CALVERT CLIFFS NUCLEAR POWER PLANT, UNIT NO. 1

DOCKET 50-317

CEN-204-(B)-NP

ANSWERS TO NRC QUESTIONS FOR  
CALVERT CLIFFS 1 CYCLE 6 - SET NO. 1

FIGURE 1

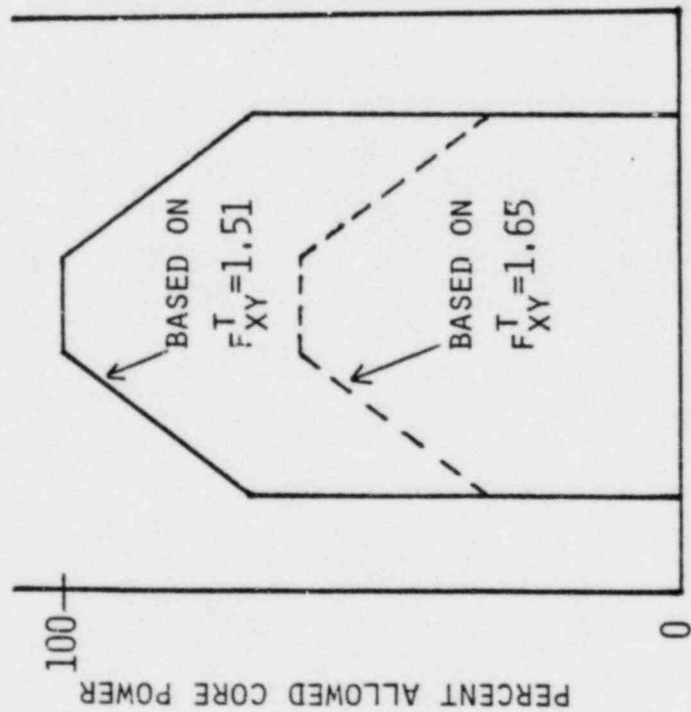
Explain in more detail the changes which have resulted in the revised Figure 3.2-2 for Linear Heat Rate Axial Flux Offset Control limits. Justify the increase in allowable rated thermal power to 100% between ASIs of  $-.06$  and  $+.12$  (T.S. Change #7).

(old T.S. Figure 3.2-3) as illustrated in Figure 1\*. The [ ] was used to directly calculate the allowed core power (old Specification 3.2.2) and to calculate a scaling factor for adjusting the ex-core LHR LCO curve (N factor in old Specification 4.2.1.3). When the peak linear heat rate was monitored with the in-core system, the allowed thermal power in Figure 1 was 100% of rated power. When the peak linear heat rate was monitored with the ex-core system, the allowed thermal power in Figure 1 was represented by the ex-core LHR LCO curve.

There are presently two systems for monitoring the core peak linear heat rate which are capable of maintaining the peak linear heat rate within the limits imposed by LOCA requirements: (1) the in-core detector monitoring system (Specification 4.2.1.4) and (2) the ex-core detector monitoring system (Specification 4.2.1.3). Normally, the first line monitoring system is the in-core system. Ex-core monitoring is used only when the in-core monitoring system becomes unavailable (such as resulting from a temporary on-line computer outage).

For reload cycles prior to Cycle 6 ex-core monitoring of peak linear heat rate impeded full power capability due primarily to the use of a conservative value for the unrodded total planar radial peaking factor ( $F_{xy}^T$ ) in the analysis which synthesized the ex-core LHR LCO curve (T.S. Figure 3.2-2). A conservative value of  $F_{xy}^T$  was used since  $F_{xy}^T$  is not an input parameter to the ex-core monitoring system. The assumed  $F_{xy}^T$  was intended to conservatively bound the expected values for the reload cycle of interest.

The  $F_{xy}^T$  factored into the ex-core LCO was also factored into the Axial Flux Offset LSSS (T.S. Figure 2.2-1). The assumed  $F_{xy}^T$  became a Technical Specification limit (old Specification 3.2.2) which had to be properly monitored to assure that both the ex-core LCO and the Axial Flux Offset LSSS remained conservative. If the unrodded  $F_{xy}^T$  limit was exceeded during normal operation, the  $F_{xy}^T$  LCO required that the increase in measured  $F_{xy}^T$  be traded off with a reduction in the allowed core power in such a way that both the ex-core LHR LCO and the Axial Flux Offset LSSS remained conservative for the higher measured  $F_{xy}^T$ . [

In order to allow full power capability with the ex-core system and also avoid unnecessary short term power level changes in the event of a temporary on-line computer outage, a parametric analysis was performed for Cycle 6 to determine the trade-off between the ex-core LHR LCO and the N factor curve. This analysis showed that an ex-core LHR LCO based on a lower unrodded  $F_{xy}^I$  limit of 1.51 instead of the Cycle 6 Technical Specification limit of 1.65, would allow full power operation for ASIs between -0.06 and +0.12 (T.S. change #7). Lowering the reference unrodded  $F_{xy}^I$  limit to 1.51 resulted in a more restrictive N factor curve as illustrated in Figure 2. This justified the need for making the N factor curve a separate specification [ ] (T.S. change 8 and 10). The reference  $F_{xy}^I$  limit factored into [ ] was not reduced to 1.51.

FIGURE 2

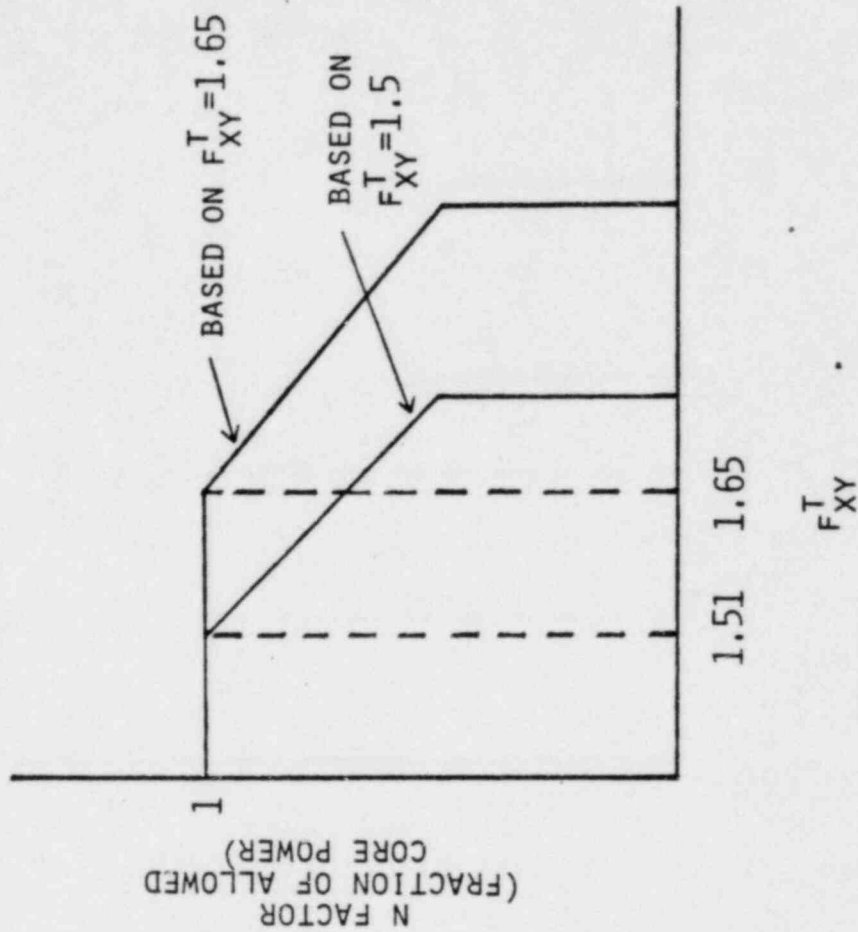
Explain in more detail the reason for the addition of T.S. 3.2.2.2. How was Figure 3.2-3b derived (T.S. change #14)?

As discussed in the answer to question Number 4, the ex-core LHR LCO was based on a lower  $F_{xy}^I$  limit to allow full power operation. Lowering the reference  $F_{xy}^I$  limit for the ex-core LHR LCO resulted in a very limiting N factor curve which justified the need for making the N factor curve a separate specification (T.S. change 8 and 10). This avoids an unnecessary penalty on allowed core power when monitoring with the in-core system.

The N factor curve in T.S. Figure 3.2-3b represents the [

] The T.S. Figure 3.2-3b will be used to calculate, in conjunction with Figure 3.2-2, the allowed core power level as a function of measured  $F_{xy}^I$  and the axial shape index when the in-core alarm system is out of service.
